Reference: Addendum to Report of Geohazard Exploration – SUM-271-8.87 – PID: 103930 - FINAL Summit County, Ohio

SUM 271 Landslide Investigation

FS=1.0 - 10 ft Slip Surface

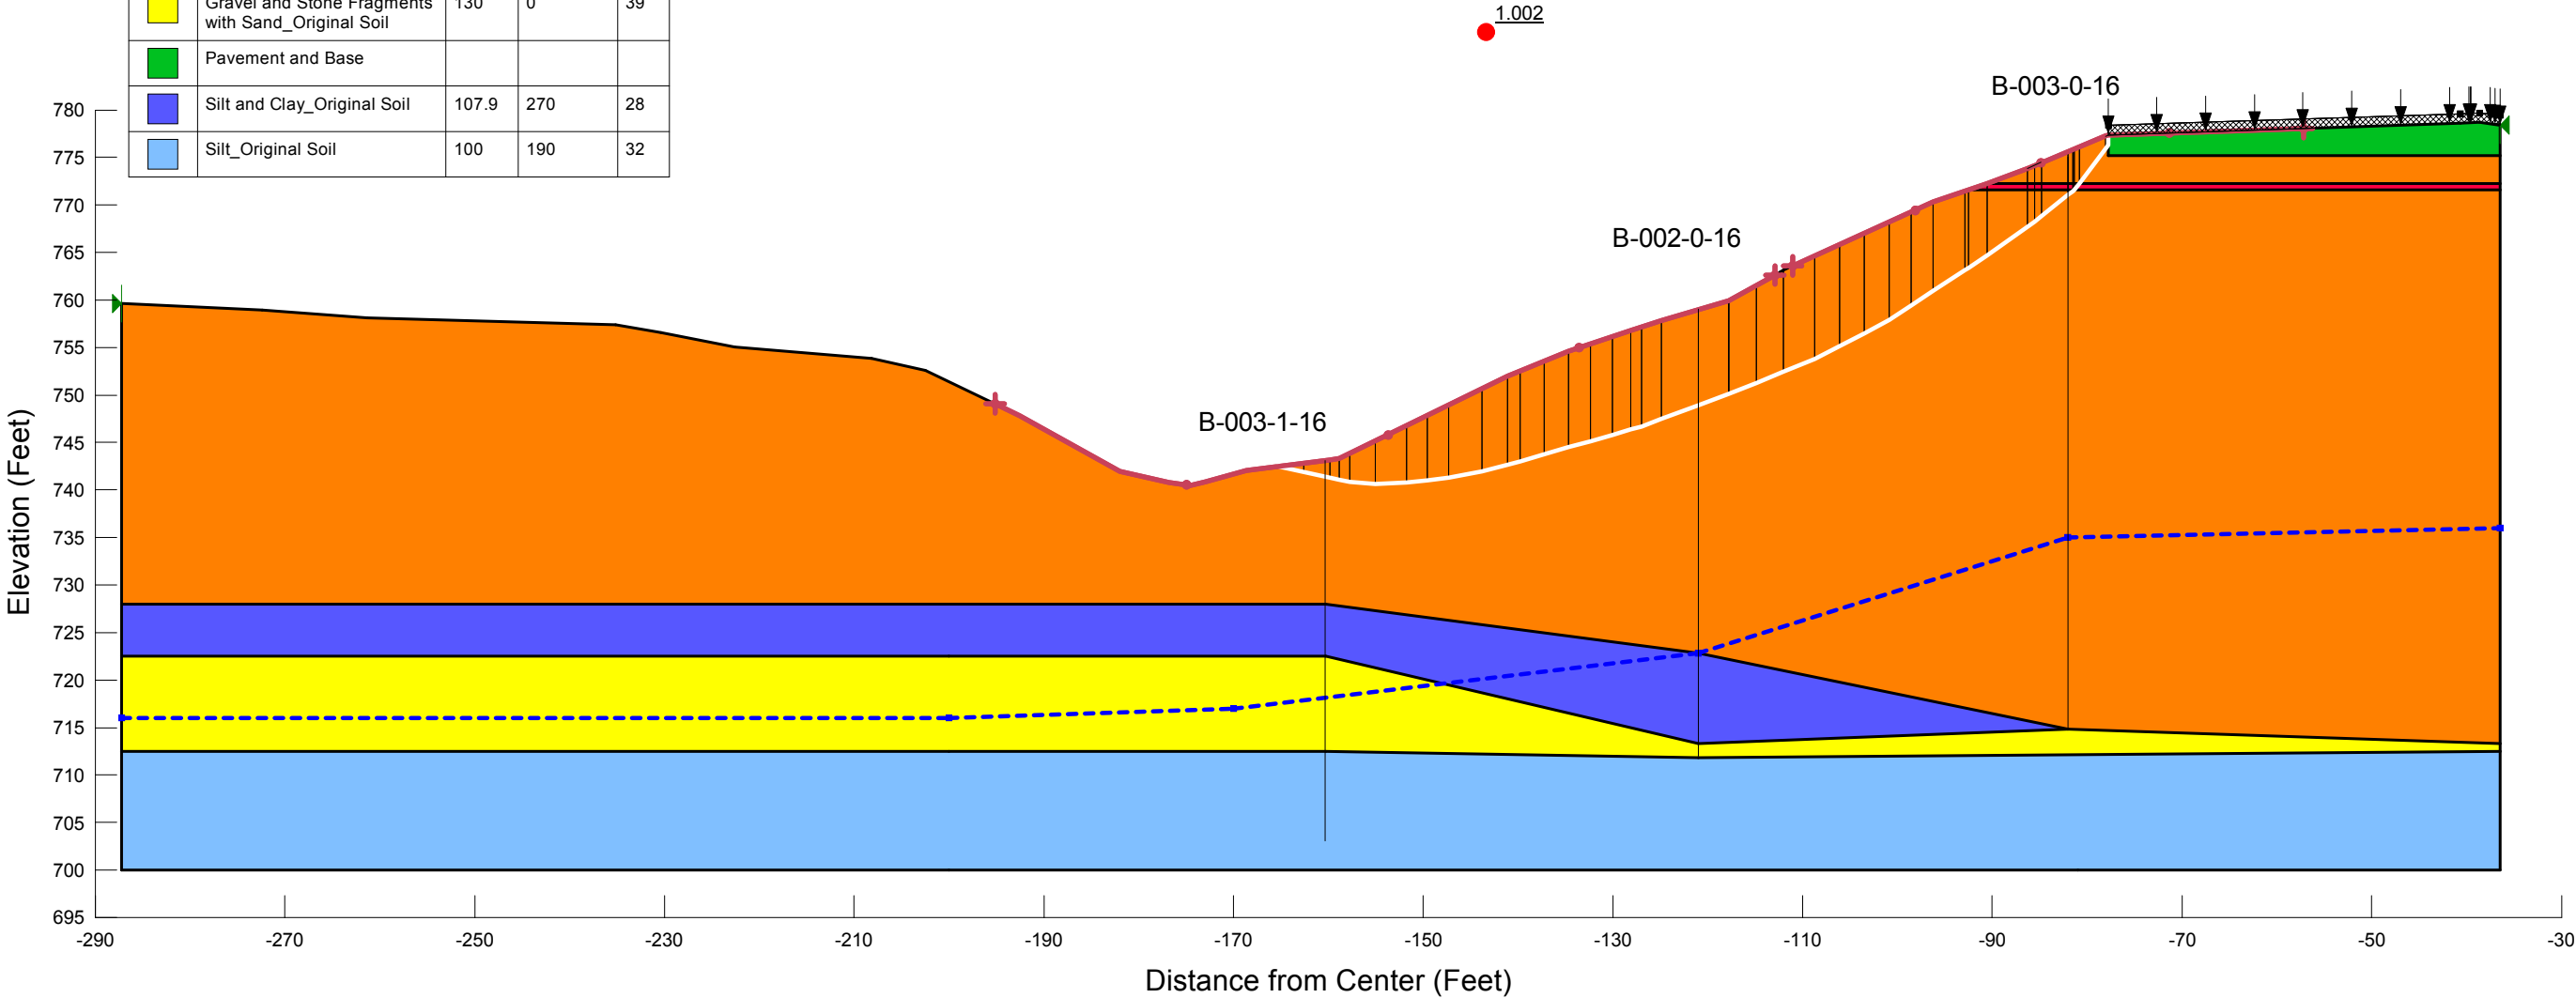
The following addendum includes the updated slope stability analyses based on the additional survey provided by ODOT-District 4. It should be noted that the back calculated effective phi angle for the existing embankment fill material decreased from 22.9 degrees to 20.7 degrees. The change in the phi angle was a result of the additional survey data that was not provided at the initial exploration stage of this project. We appreciate the opportunity to provide you with these services, and please do not hesitate to contact us with any questions or comments.
